**Item 3.****Development Application: 1049, 1051 and 1053-1055 Bourke Street, Waterloo - D/2019/1082****File No.:** D/2019/1082**Summary**

**Proposal Summary:** The subject application seeks consent for a mixed-use concept building envelope incorporating retail and boarding house land uses.

**Figure 32:** Street frontage heights of up to 4-storeys in the vicinity of the site

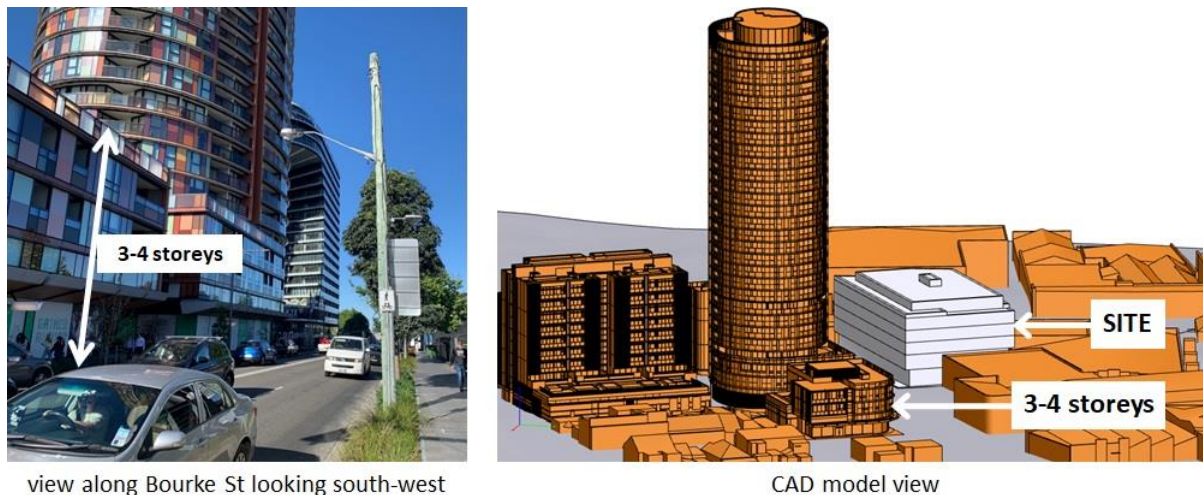
54. As shown in **Figure 32** below, in the vicinity of the site, the south-eastern side of Bourke Street with the exception of the Infinity building, is characterised by a low street wall.

57. In accordance with the DCP provisions noted above and the advice of the City's Design Advisory Panel (DAP), a condition is recommended for design requirements to be addressed in the future competitive design process brief and detailed design DA to provide a maximum street frontage height of 4-storeys to Bourke Street. Any storeys above the street frontage height are to be setback a minimum of 3m, in accordance with DCP provision 4.2.1.1.

**Figure 33:** Recommended 9m setback from rear boundary

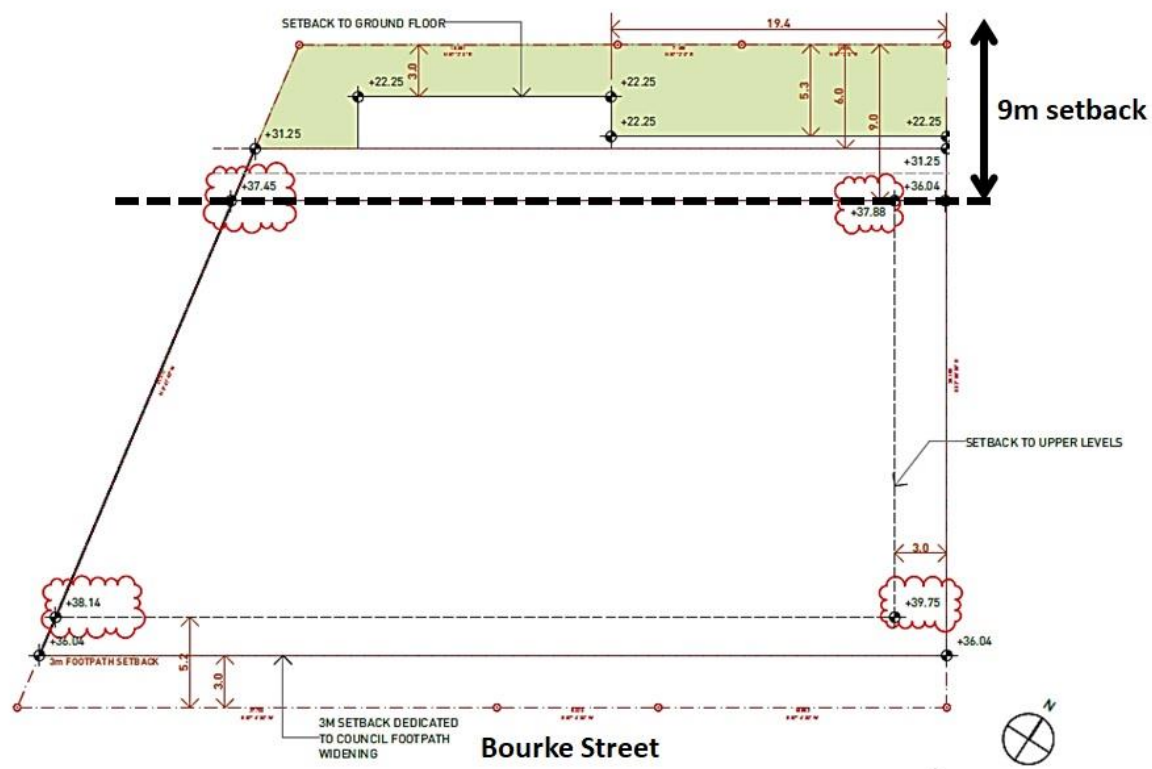
66. The roof plan of the reference scheme breaches the concept envelope's 3m setback from the north-eastern boundary above RL 36.04.
67. To address these non-compliances, a condition is recommended for the concept envelope to be setback 9m from the rear boundary as shown in **Figure 33** below. This will reduce the amount of space available for car-parking, reduce the amount of above ground car-parking and will provide a contiguous deep soil area to address deep soil requirements and to provide opportunities for landscaping for improved amenity for the proposed development and to provide separation and screening to and from adjacent properties.

68. The substantial voids and large ground level servicing dock of the reference scheme suggest that the envelope can comfortably accommodate the maximum permissible FSR for the site. However, recommended conditions for an increased rear setback, a maximum 4-storey street frontage height, provision of minimum floor to floor and floor to ceiling heights and other requirements may make the up to 10% additional floor space for design excellence difficult to achieve.

71. As detailed elsewhere in this report, a condition is recommended to set the concept envelope back 9m from the north-western (rear) boundary. Based on the submitted reference scheme and as illustrated in **Figure 35** above, this would remove 2 car-parking spaces resulting in 52% (12 of 23) car-parking spaces being above-ground and which is more in-keeping with the control.
72. A condition is recommended for design requirements to be addressed in the future competitive design process brief and detailed design DA including that no more than 50% of car-parking spaces are to be above ground.

**Figure 34:** Section illustrating portion of car-parking area provided above ground

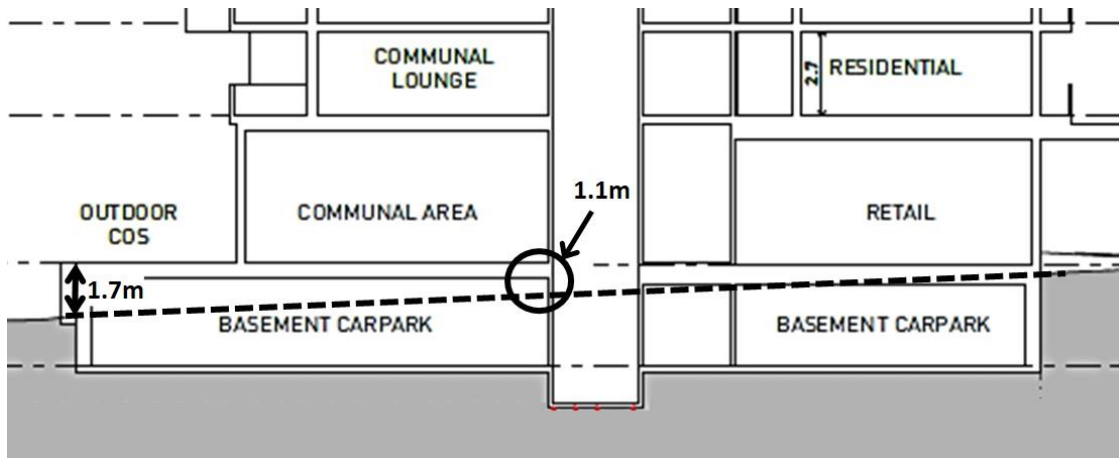
69. As shown in **Figure 34** below, in the reference scheme the portion of the car-parking area that is north-west of the central core, protrudes above ground level by 1.1m to 1.7m.

**Figure 35:** Illustration of indicative loss of car-parking resulting from 9m rear setback

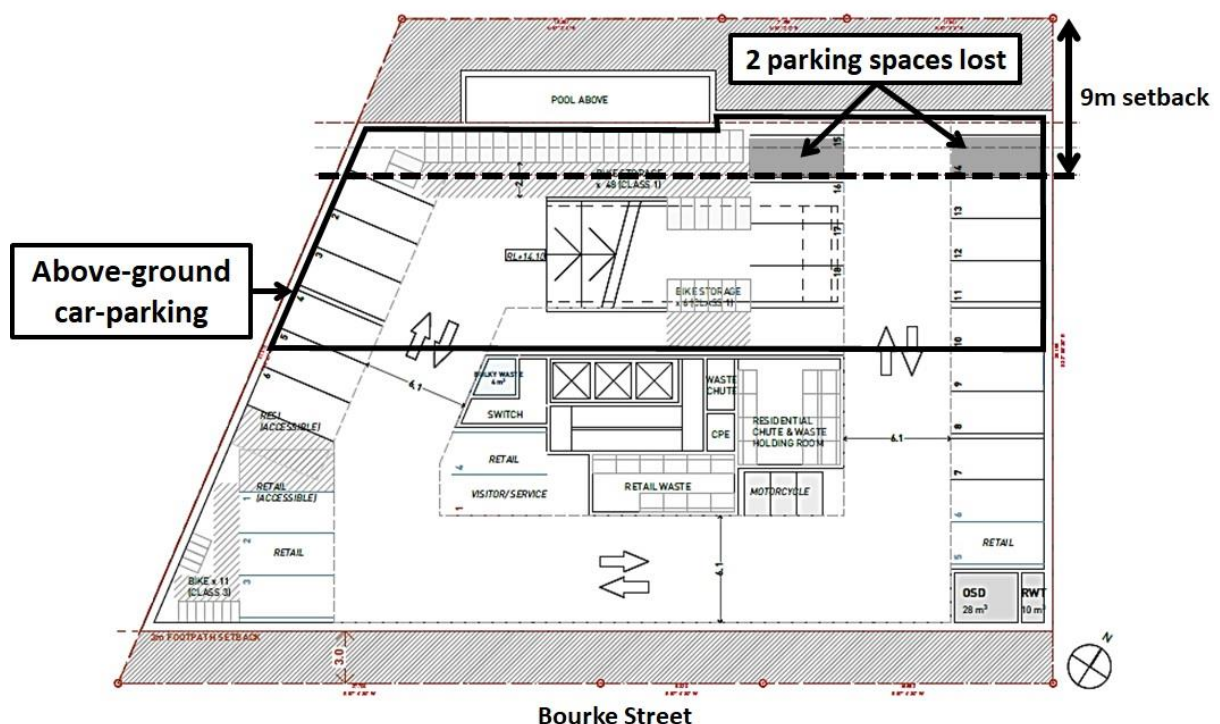
70. This above ground parking area, shown in **Figure 35** below, comprises 56% (14 of 25) of car-parking spaces in the reference scheme. This exceeds the maximum 50% above ground car-parking permitted under the DCP.

**Figure 36:** Level 4 - reference scheme plan with balconies recessed behind public domain setback

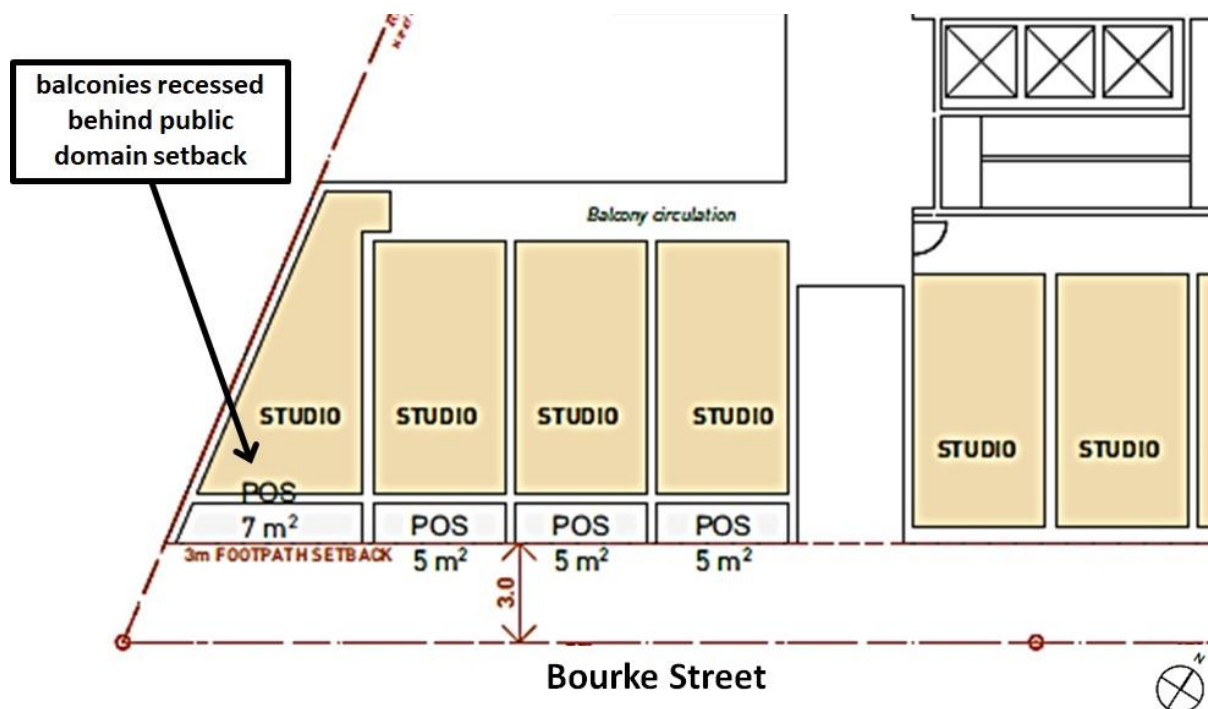
82. The applicant has made a public benefit offer and agreed to enter into a VPA to dedicate land for footpath widening on Bourke Street in accordance with the *Public Domain Setbacks Map* and the requirements of provision 5.2.10 of the DCP.
83. The concept envelope drawings have been amended so that the Bourke Street elevation aligns with the public domain setback. In plan, as shown in **Figure 36** below, the reference scheme is consistent with the concept envelope, and indicates balconies to the Bourke Street facade being recessed behind the public domain setback alignment.

**Figure 37:** Section - reference scheme showing balconies overhanging public domain setback

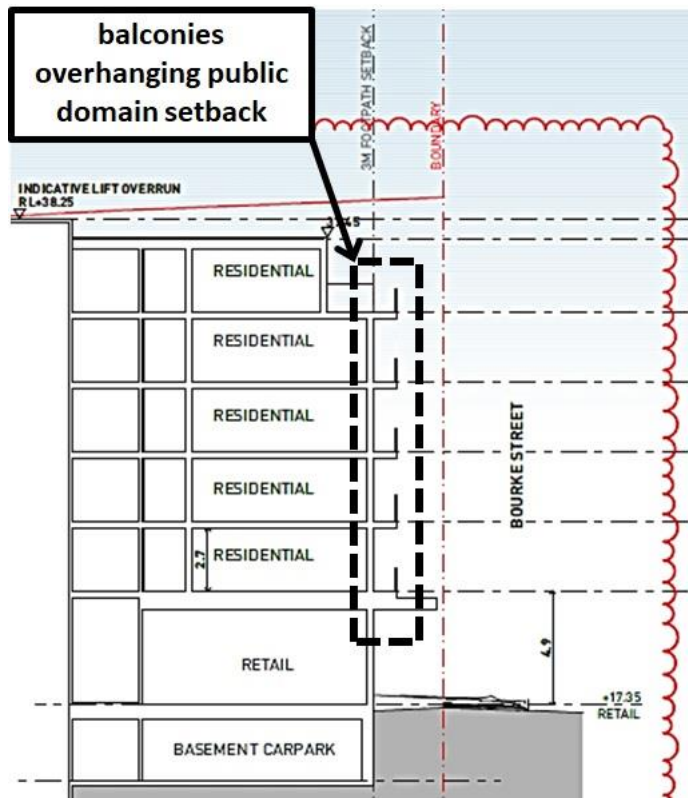
84. However, in section as shown in **Figure 37** below, the reference scheme indicates balconies overhanging and encroaching upon the public domain setback to be dedicated to Council.

85. A condition is recommended for design requirements to be addressed in the future competitive design process brief and detailed design DA including that there are to be no such encroachments into the public domain.
